SERVICE DIRECTIVE BULLETIN NO. T-040

1. SUBJECT: Cyclic Trim Actuator Switch Assembly Inspection
2. MODEL: TH-28, 480, 480B
3. EFFECTIVITY: S/N 5142 and prior
4. BACKGROUND:

Figure 1. Properly Installed Screws – The heads of the inner screws face the spring capsule.

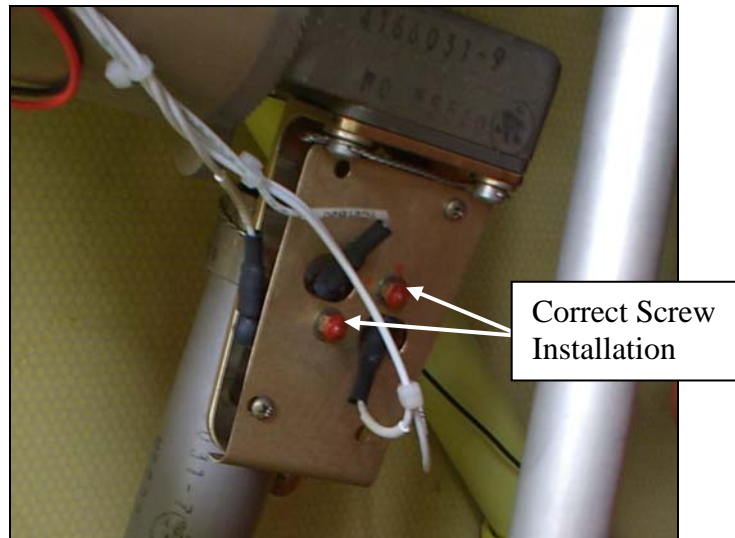
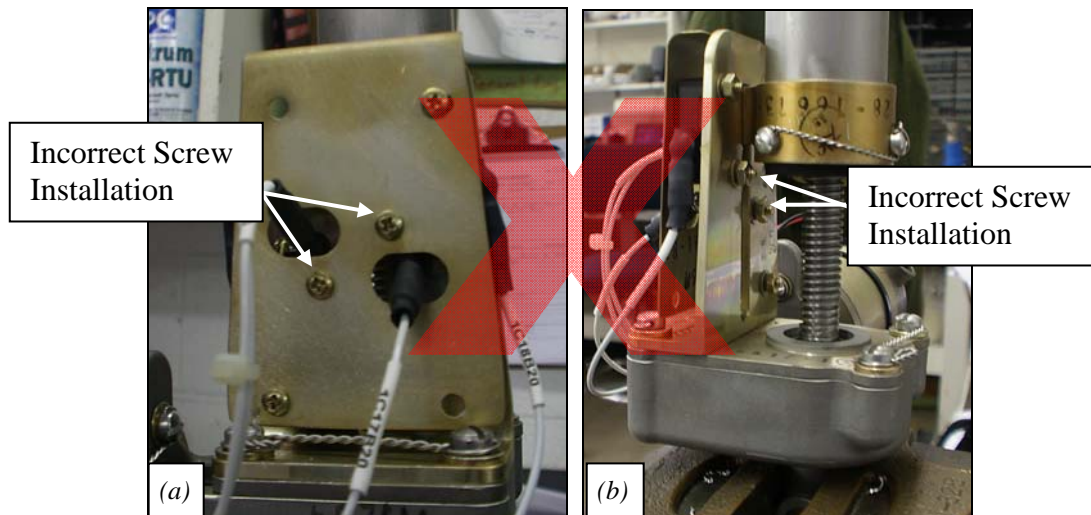
- 6.1 Locate the lateral trim actuator assembly through the left engine access panel. Locate the longitudinal trim actuator assembly through the right engine access panel.
- 6.2 Inspect the lateral and longitudinal trim switch assemblies for the proper screw orientation. The screw shanks and nuts should be visible on the wiring side of the switch assembly (*Figure 1 and Figure 2*). The heads of inner screws should be facing the spring capsule. NOTE: On 480-series aircraft, the outer screws may be installed in either orientation.

Figure 2. Improperly Installed Screws (a) (b) – The shanks of the inner screws face the spring capsule (b). (The trim actuator is removed from the aircraft.)

Figure 3. Cyclic Trim Switch Assembly

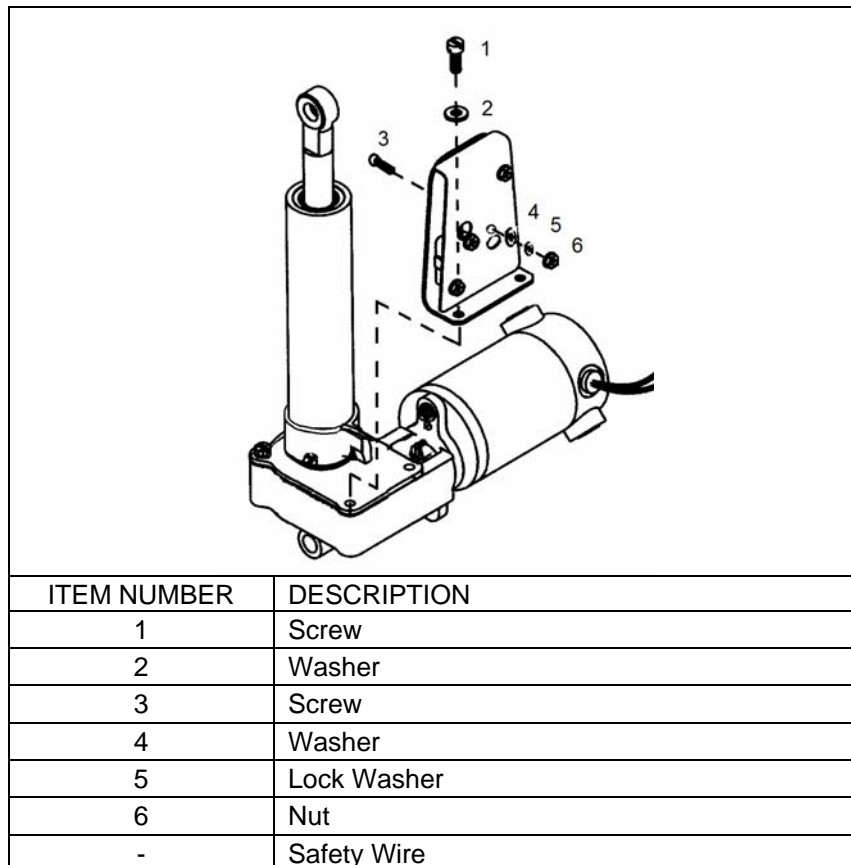
- 6.7 Remove the safety wire, screws (1) and washers (2) attaching the switch assembly to the trim actuator. Remove the switch assembly (*Figure 3*).

- 6.8 Remove the inner screws (3), washers (4) (5), and nuts (6) from the switch assembly. Re-install the inner screws (3), washers (4) (5), and nuts (6) such that the screw heads face the spring capsule. Use care to avoid moving the position of the switches when installing the screws.
- 6.9 Re-install the switch assembly to the trim actuator assembly with the hardware removed in step 6.7 and safety wire.
- 6.10 Check the spring housing travel. Refer to SDB T-039 Rev. 3, or latest revision, for instructions on checking the travel and making required adjustments.
- 6.11 Apply VC-3 Vibra-Tite, or equivalent, to the exposed screw threads and nut face.
- 6.12 Re-install the trim actuator assembly in accordance with paragraph 12-74 of the maintenance manual.
- 6.13 Check for proper operation of the trim actuator assembly.
